DART SERVICE INSTRUCTION

TO AMEND INSTALLATION INSTRUCTIONS IIN-D407-781-2 REV. A OR LATER APPROVED REVISION
AND INSTRUCTIONS FOR CONTINUED AIRWORTHINESS ICA-D407-781 REV. 3 OR LATER REVISION

In some aircraft, the top portion of the D206-781-041 Baggage Compartment Wall Protector Kit cannot be installed as indicated in IIN-D407-781-2. The purpose of this DSI is to provide an alternate mounting method to fasten the top portion of the D206-781-041 Baggage Compartment Wall Protector Kit.

A	NEW ISSUE		13.04.08
REV.	DESCRIPTION	BY	DATE
DESIGN			
DRAWN			
CHECKED			
MFG. APPR.	N/A		
APPROVED			
DE APPR.			
DATE	13.04.08		
DART AEROSPACE LTD HAWKESBURY, ONTARIO, CANADA		REV. A SHEET 1 OF 2	
DRAWING NO. DSI 9649		SCALE NTS	
TITLE ALTERNATE INSTALL			
COPYRIGHT © 2013 BY DART AEROSPACE LTD. THIS DOCUMENT IS PRIVATE AND CONFIDENTIAL AND IS SUPPLIED ON THE EXPRESS CONDITION THAT IT IS NOT TO BE USED FOR ANY PURPOSE OR COPIED OR COMMUNICATED TO ANY OTHER PERSON WITHOUT WRITTEN PERMISSION FROM DART AEROSPACE LTD.

**FIGURE 1 - D3879-1 BAGGAGE COMPARTMENT WALL
PROTECTOR - ALTERNATE INSTALLATION**

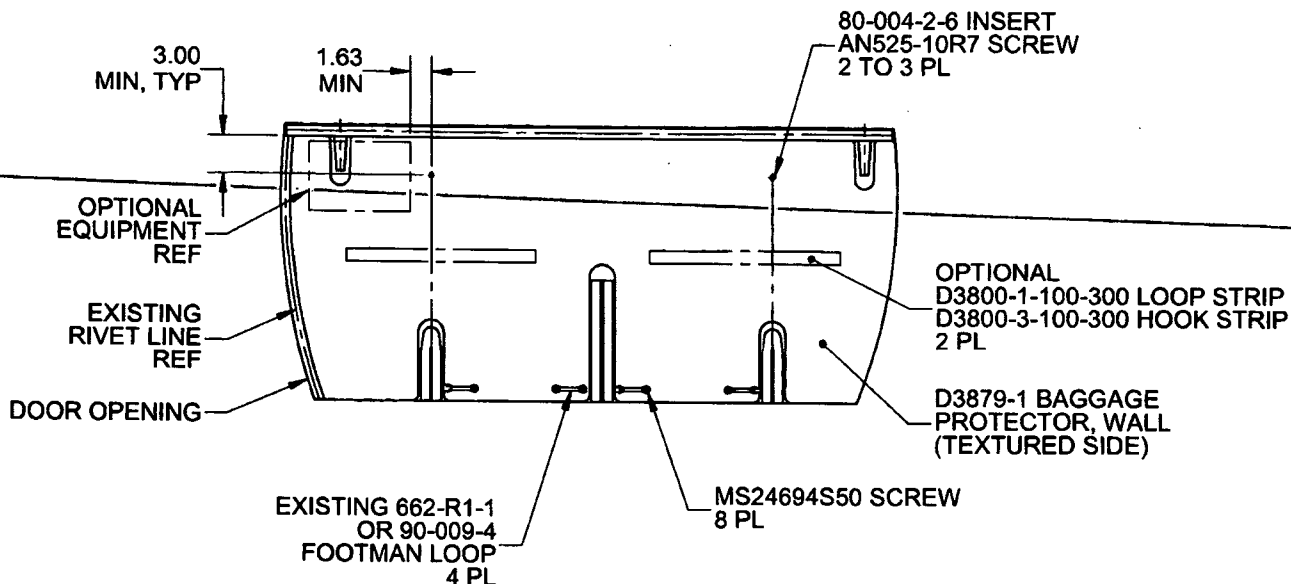
It is acceptable to replace qty(2) D3930-1 Clips with qty(2) 80-004-2-6 Inserts. Locate and mark location of the two attachment holes on the baggage compartment wall as shown in Figure 1 of this service instruction. Install 80-004-2-6 Inserts at the marked locations in accordance with Section 3-2-12 of BHT-206-SRM-1. It is acceptable to trim the wall protectors to accommodate optional equipment or transfer attachment holes to the wall protector and install the optional equipment on top of the wall protector with longer fasteners.

Amend the D206-781-041 Baggage Compartment Wall Protector Kit parts list as follows:

Qty -061	Qty -031	Qty -041	Part Number	Description
X			D206-781-061	BAGGAGE COMPARTMENT PROTECTOR KIT (FLOOR AND WALL)
1	X		D206-781-031	BAGGAGE COMPARTMENT FLOOR PROTECTOR KIT
1		X	D206-781-041	BAGGAGE COMPARTMENT WALL PROTECTOR KIT
		2	AN525-10R7	SCREW
		2	80-004-2-6	INSERT
